UNITED STATES PATENT AND TRADEMARK OFFICE

| APPLICATION NO. | FILING DATE | FIRST NAMED INVENTOR | ATTORNEY DOCKET NO. | CONFIRMATION NO. |
|--|-------------|----------------------|---------------------|------------------|
| 10/810,452 | 03/26/2004 | Sehat Sutardja | MP0467 | 8949 |

DATE MAILED: 08/10/2005

DETAILED ACTION

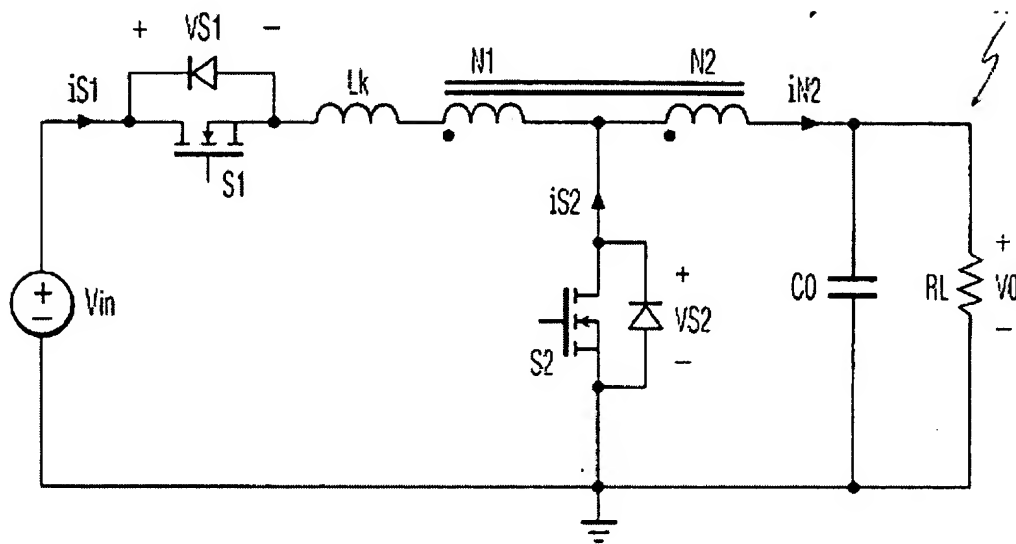
3. Claims 1, 2, 5, 6, 9, 11, 12, 15, 16, 19, 21 and 23 rejected under 35 U.S.C. 102(b) as being clearly anticipated by Qian (USP 6,512,352). Qian discloses the claimed invention a coupled inductor with first, N1, and second, N2, windings connected in series to form a common node, a conduction switch, S1, and a freewheeling switch, S2, the inductor is formed on a single core, and an output capacitor, Co. See figure below.
